Jericho Project Final EIS  
Supplemental Report

**Tahera Corporation**  
Toronto, Ontario

**AMEC Earth & Environmental Limited**  
Burnaby, BC

September 2003

**Figure 2.1.1-1 Coarse PK Particle Size**

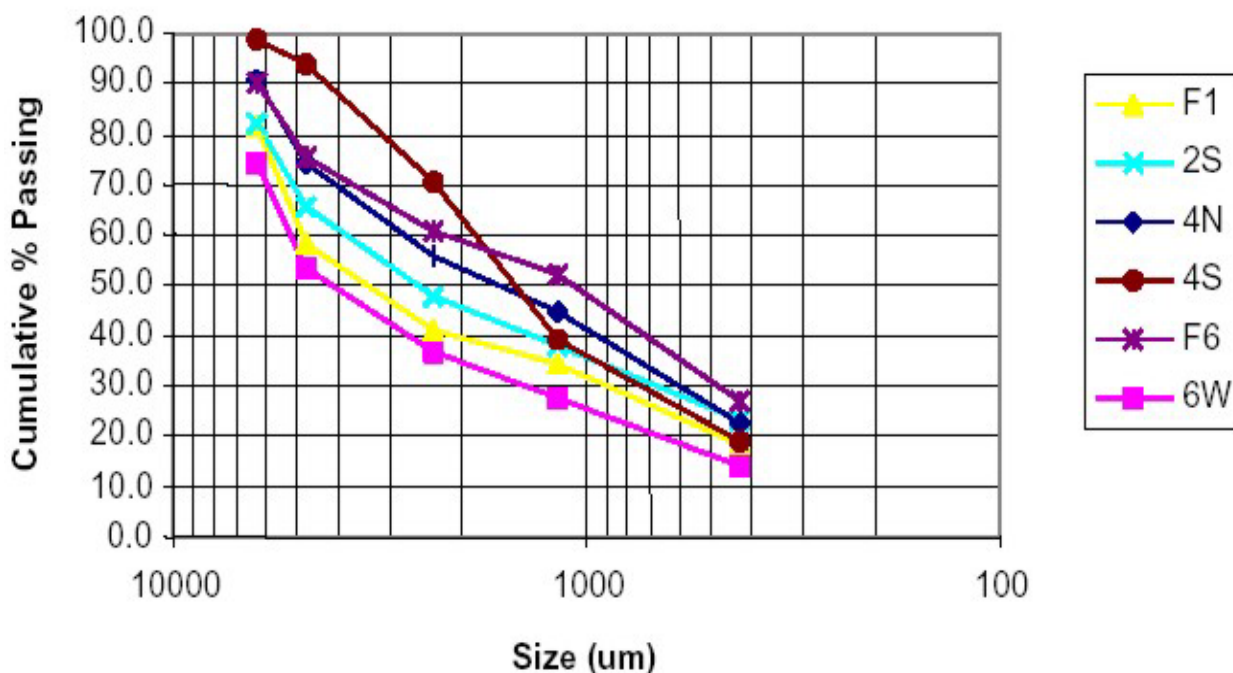
The Air Quality Assessment (Appendix D.1.1) does not indicate the estimated silt content or moisture content for the coarse tailings stockpile. Tahera should provide a rationale (with support information on silt and moisture content) on why the coarse ore stockpile is ruled out as a source of fugitive dust.

In the plant the coarse PK material is repeatedly washed until essentially all the fines are removed. The resultant material is deposited wet and is pea-gravel size for the most part. A particle size analysis done on pilot plant coarse PK which underwent considerably less washing than would occur in a full scale plant is shown below. The estimated moisture content of the coarse PK going to the stockpile is 12%. Finally, based on EKATI™ experience (EKATI™, pers. comm. 2003), fugitive dust emissions from their coarse PK dump have not been problematic since mine start up.

### FIGURE 3.2 HYDROLOGY STATIONS

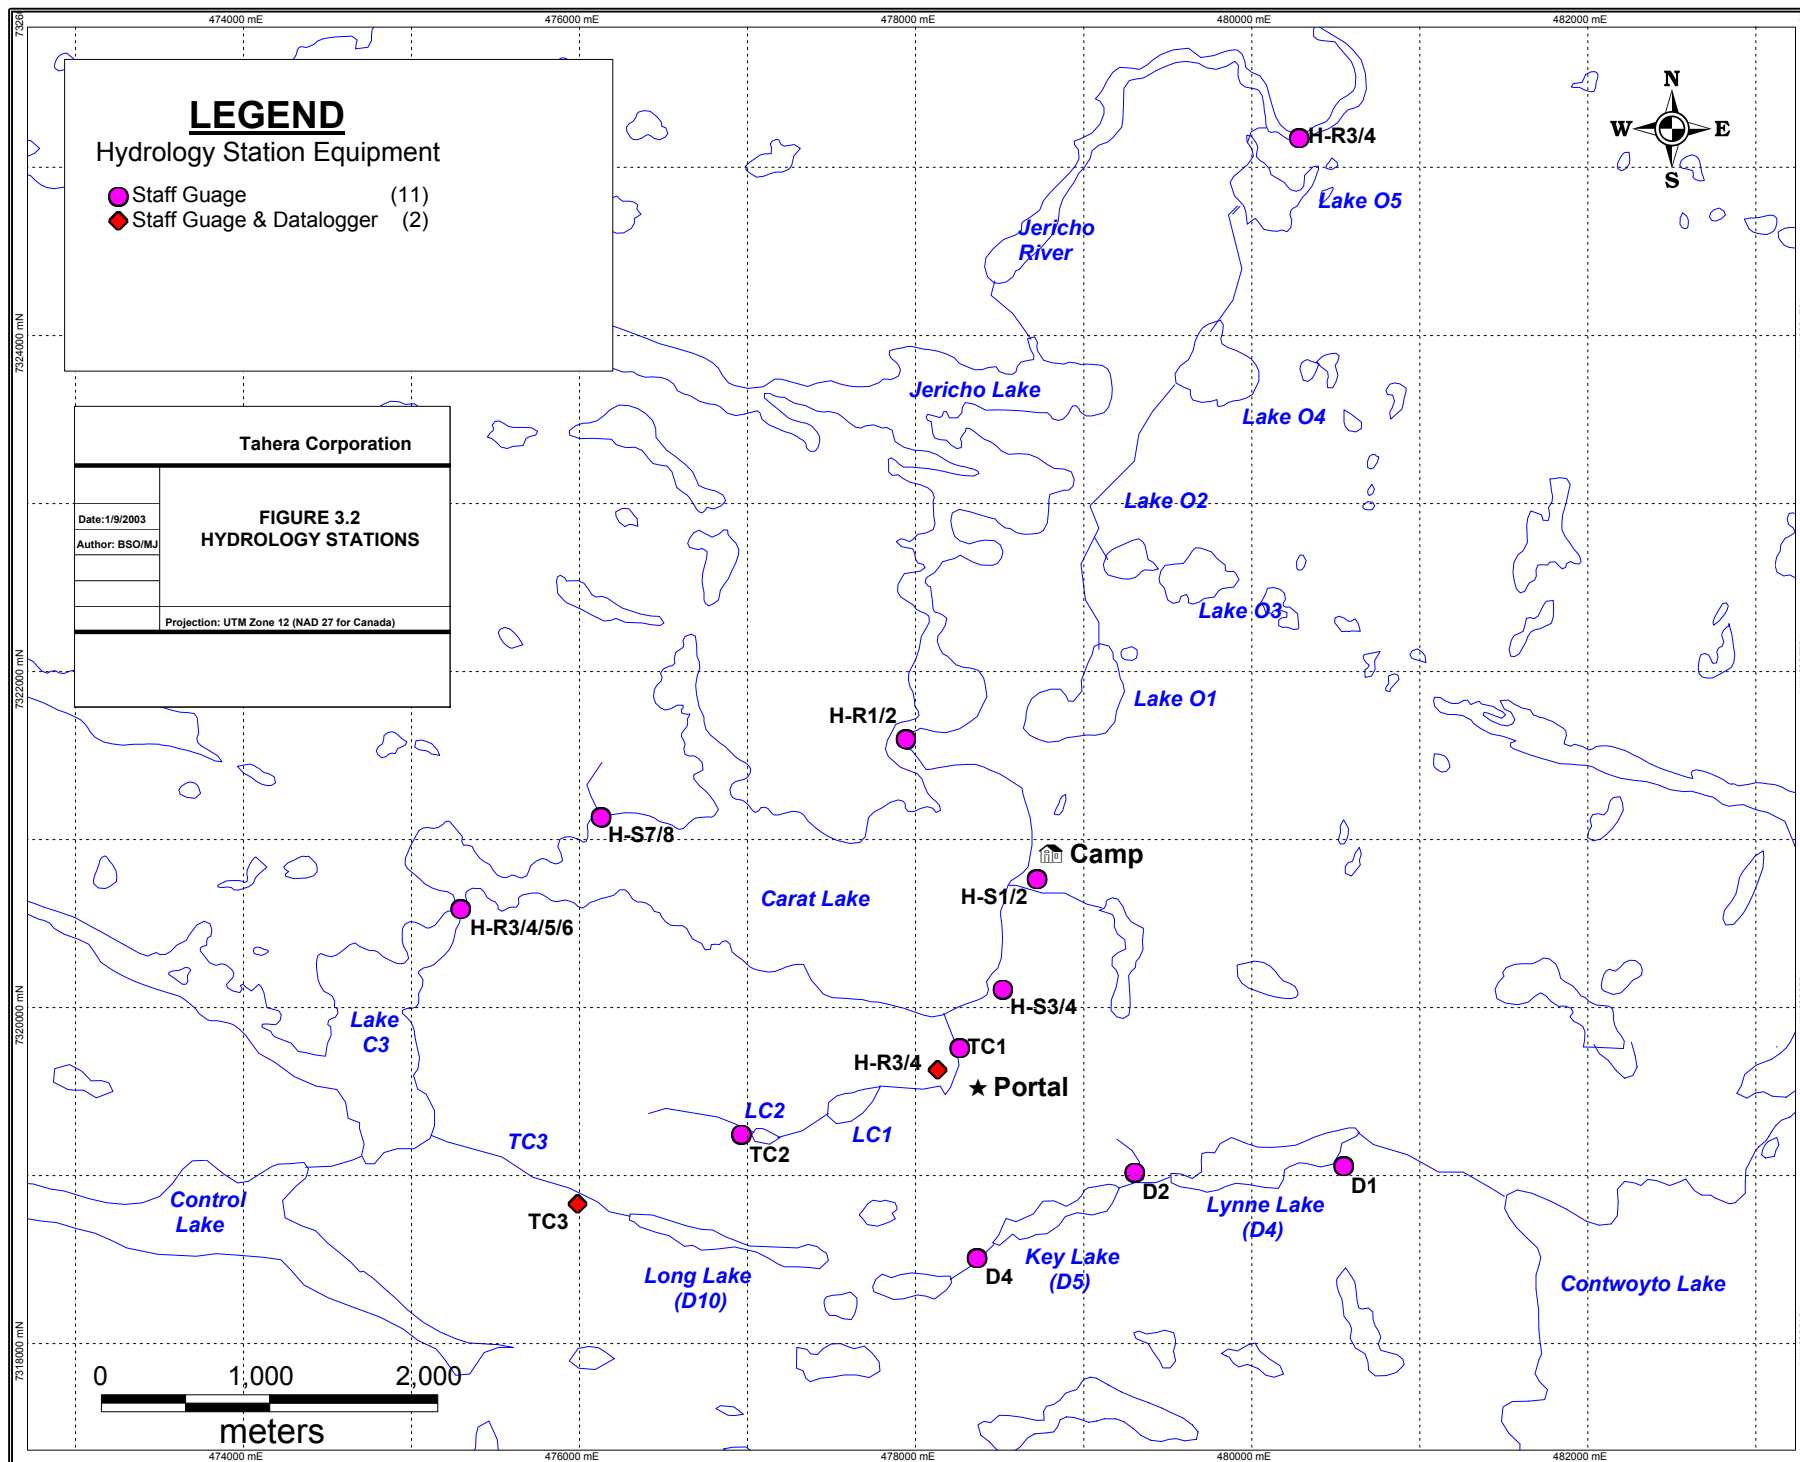
Figure 3.2 of Appendix B.1.1 (baseline Summary Report) does not show the location of station H-S3/4 nor does it show all monitoring locations stated in Section 3.2.

Tahera should incorporate all monitoring locations in Figure 3.2. In addition, Tahera should distinguish between monitoring locations with staff gauges and those with automated dataloggers.

Modified Figure 3.2 attached as Attachment 2.1. WSC stations cannot be shown at the scale required for site stations.

Figure I. Diagram of the System Tested and Sampling Location

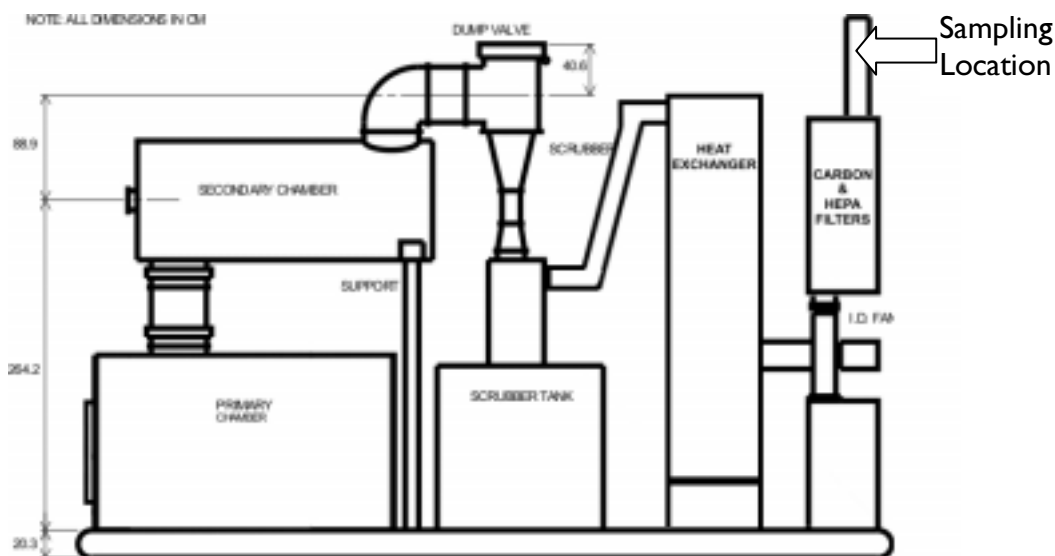
1. Nunavut Guidelines for municipal solid waste do not endorse open burning. Incinerator design should be provided.
2. Incinerator ash is considered highly susceptible to leaching of metal elements. Ash from domestic solid waste incinerators is usually classified as hazardous.
3. No details or drawings of the landfill design are provided, nor are any monitoring plans associated with the landfill. In addition, the EIS does not outline any specific land filling procedures to avoid land filling of leachable materials.

1. The Final EIS does not suggest municipal solid wastes (called domestic waste in the EIS) would be burned in the open. The incinerator design was not provide because standard, readily available technology of approved design would be installed at the Jericho camp suitable of handling domestic wastes from a 100 person camp. The incinerator would only be used intermittently for a few hours per day (compared to generators and other exhaust emission sources which would be operated continuously). It was therefore not considered in the air quality assessment.

A camp incinerator of a design suitable for Jericho is provided in Attachment 2.2. Consideration of air quality impacts are discussed in the Levelton response (Levelton 2003).
